Residential Development at Shangan Road, Co. Dublin

Combined Stage 1 & 2 Road Safety Audit

Document Ref: P21-090-PSW1-RP-001

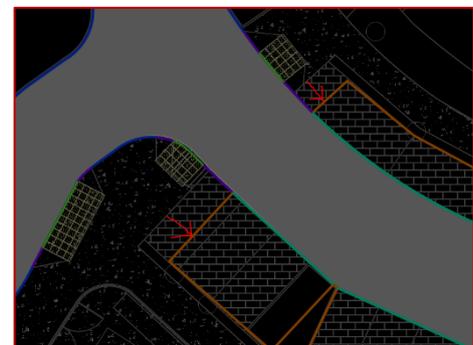
Location: New Junction at the Western Extents of the Scheme

Summary: Visually impaired pedestrians may inadvertently enter the carriageway, where there is an increased risk of being struck by a vehicle.

It is unclear if the raised table will be set flush with the surrounding footway. Should the raised table be level with the surrounding footway, there is a risk that visually impaired pedestrians may be unable to identify the footway edge, and inadvertently continue into the carriageway where there is a risk of vehicle/pedestrian collisions.

Location: New Junction at the Western Extents of the Scheme

Summary: Absence of footway connection may increase the risk of slips, trips, and falls.

It is not clear from the sketch provided if a new footway connection will be provided between the existing Shangan Road footway in the north, and the new access road in the east. Failure to provide a pedestrian footway linking the two footways may lead to informal pedestrian routes through grassed areas, which may become worn and rutted over time, leading to ponding, slips, trips, and falls.

The plateau of the raised table should be set lower than the surrounding footway, allowing visually impaired pedestrians to identify the kerb edge.

Ensure a pedestrian footway connection is provided between Shangan Road and the new development access road.

Additionally, the uncontrolled pedestrian crossing on the minor arm should be relocated to the south along the east-to-west desire line.

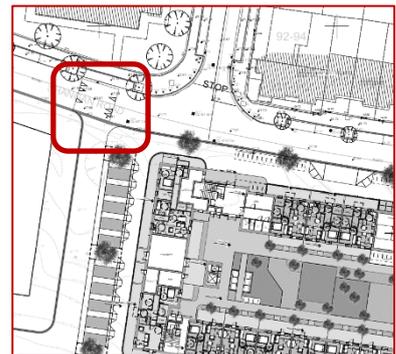
Location: Drawing No SHB3-BAL-AR-COA-DR-006 (Rev P04)

Summary: Existing speed table on Shangan Road may interfere with the safe movement of vehicles entering/exiting the development.

The location of a raised speed table directly adjacent one of the development accesses may complicate the safe movement of vehicles entering or exiting the development, leading to driver hesitation. This may increase the risk of rear-end-shunt collisions.

The speed table should be relocated so as not to interfere with entry/exit manoeuvres, or a raised table should be provided at the junction.

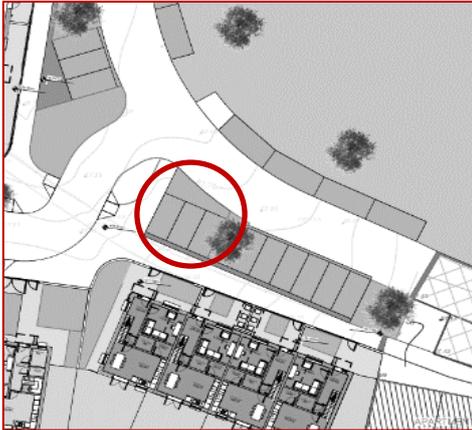
Location: New Uncontrolled Pedestrian Crossing at Public Open Space

Summary: Vehicle speeds near uncontrolled pedestrian crossing may increase the risk of vehicle/pedestrian collisions.

The new pedestrian link between the development and the Public Open Space, which will include a playground, basketball court and grassed areas, is likely to be a popular route for residents. The pedestrian route is likely to attract small children and scooter users, who may be less attentive when crossing the road. The RSA Team supports the measures taken to increase inter-visibility between pedestrians and drivers, but are concerned that vehicle speeds in this area may be high. This could lead to vehicle/pedestrian collisions at the crossing.

Parking should be relocated further east to maximise inter-visibility between pedestrians and drivers, and a raised junction table should be provided in this location to passively control vehicle speeds.
